APPLICATION NO.	FILING DATE	FIRST NAMED INVENTOR	ATTORNEY DOCKET NO.	CONFIRMATION NO.
10/593,047	09/15/2006	Jean-Pierre Pages	15338NP	7277
293 DOWELL & D	7590 08/26/200 OWELL P.C.	EXAMINER		
103 Oronoco St		DIAZ, THOMAS C		
Suite 220 Alexandria, VA 22314			ART UNIT	PAPER NUMBER
•			3656	
			MAIL DATE	DELIVERY MODE
			08/26/2009	PAPER

Application No.	Applicant(s)					
	10/593,047	PAGES ET AL.					
Office Action Summary	Examiner	Art Unit					
	THOMAS DIAZ	3656					
The MAILING DATE of this communication app							
Period for Reply		•					
A SHORTENED STATUTORY PERIOD FOR REPLY WHICHEVER IS LONGER, FROM THE MAILING DA - Extensions of time may be available under the provisions of 37 CFR 1.1: after SIX (6) MONTHS from the mailing date of this communication. - If NO period for reply is specified above, the maximum statutory period v - Failure to reply within the set or extended period for reply will, by statute Any reply received by the Office later than three months after the mailing earned patent term adjustment. See 37 CFR 1.704(b).	ATE OF THIS COMMUNICATION 36(a). In no event, however, may a reply be tin will apply and will expire SIX (6) MONTHS from a cause the application to becom

[図3]

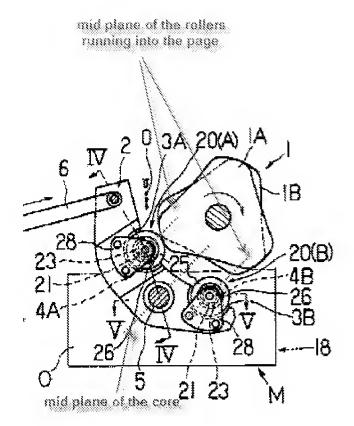
Regarding claim 5, Mizuguchi et al. discloses the respective mid-planes of said rollers are parallel (fig.3 and 4; one can draw mid-planes of said rollers which are parallel where the planes either intersect the thickness of the rollers), situated either side of and substantially at equal distances from a mid-plane of said core (fig.3, for example see labeled fig. below).
